Access Compliance Report
Public Rights-of-Way
(Curb Ramps)

Intersection ID: 3282	Main Street: OAK_ST	Cross Street: ERNEST_RUSSELL_CT	Location: E
ADA ID: 7DE4832E1D8C	Ramp Type: PerpDiag	Initial Pass/Fail: Fail	Overall Compliance: No	Severity Score: 25

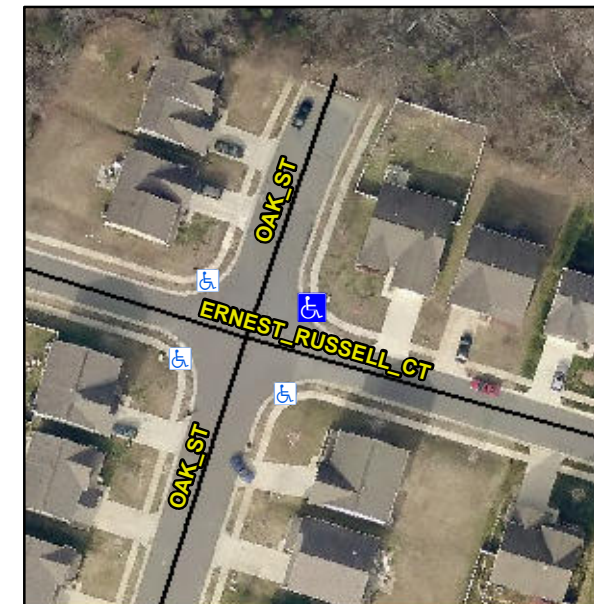
Not Found, R304.2.2, R304.5.3

Compliance	Description	Data	Compliance	Description	Data
N/A	Ramp Length (in)	48.0	No	Ramp Slope (%)	8.4
Yes	Ramp Width (in)	50.0	No	Ramp XSlope (%)	6.4
N/A	Flare Type LT	N/A	N/A	Flare Type RT	N/A
N/A	Flare Slope LT (%)	N/A	N/A	Flare Slope RT (%)	N/A
N/A	Flare Traversable LT?	N/A	N/A	Flare Traversable RT?	N/A
N/A	Landing Length (in)	N/A	N/A	DWS Provided?	N/A
N/A	Landing Width (in)	N/A	N/A	DWS Contrast?	N/A
N/A	Landing Slope (%)	N/A	N/A	DWS Length (in)	N/A
N/A	Landing X Slope (%)	N/A	N/A	DWS Full Width?	N/A
N/A	Landing Curb? (Y/N)	N/A	N/A	DWS Offset (in)	N/A
N/A	Shared Landing?	N/A			
N/A	Gutter Ponding?	N/A	N/A	Gutter Slope (%)	N/A
N/A	Gutter Lip Ht (in)	N/A	N/A	Gutter X Slope (%)	N/A
N/A	Painted X Walk1?	No	N/A	Painted X Walk2?	No
	X Walk 1 Direction	To NW		X Walk 2 Direction	To SW
N/A	X Walk 1 Width (in)	N/A	N/A	X Walk 2 Width (in)	N/A
	X Walk 1 Slope (%)	1.2		X Walk 2 Slope (%)	4.0
	X Walk 1 X Slope (%)	5.2		X Walk 2 X Slope (%)	1.2

Remove & Replace Curb Ramp With Two New Directional Ramps or Equivalent.
